Modernising Midlands Airspace

Stage 1: Define
ACP-2025-013

NATS

Figure 4 Extant military airspace structures within area of scope.

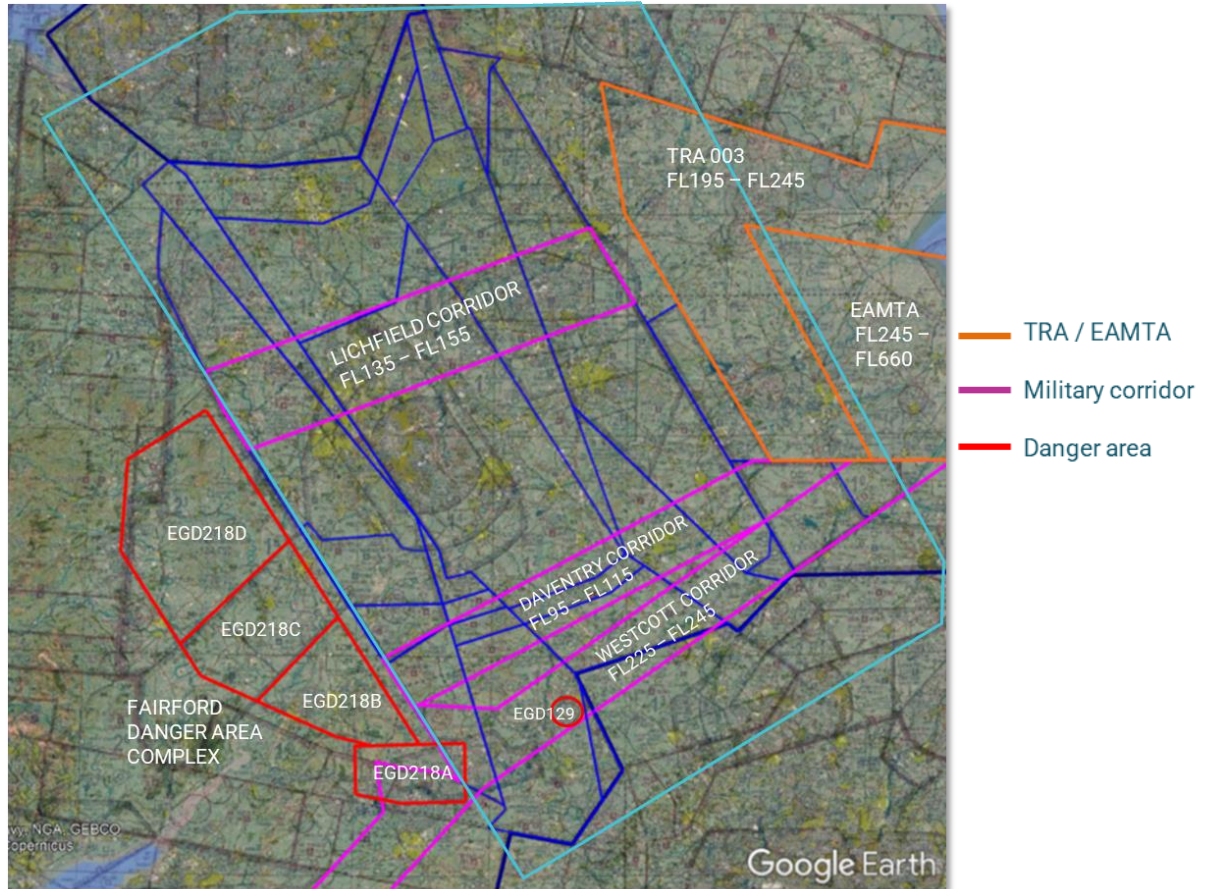
Current Day Scenario: Engagement Responses			
Stakeholder	Agree with description?	Comments	NERL Response
easyJet	Agree	Nil	
TUI airlines	Agree		
MoD (DAATM)	Agree	The description of the radar corridors was for the civil TC containment. Confirmed the radar corridors as: Lichfield FL140 & FL150 Daventry FL100 & FL110 Westcott & Swindon FL230 & FL240	Diagram revised to show available levels rather than ATC containment levels for accuracy.
MoD (RAF Brize Norton)	Neutral	Imperative to consider military activity, within Weston on the Green Danger Area, and Brize Norton CTR. Any changes negatively impacting RAF Brize Norton would not be agreeable.	Weston on the Green is identified within the current day airspace description. RAF Brize Norton CTR (SFC – 3,500ft) is out of scope of this change proposal.
General Aviation Alliance (GAA)	Agree	Nil	
British Skydiving	Agree	Nil	
Skydive Langar	Agree	Nil	
Skydive Tilstock	Agree	Nil

5.1.1. Stakeholders agree with our assessment of the current day airspace design and usage. A minor clarification was provided by DAATM – we had indicated the ATC containment area for the military corridors; this has been revised to specify the actual corridor flight levels.
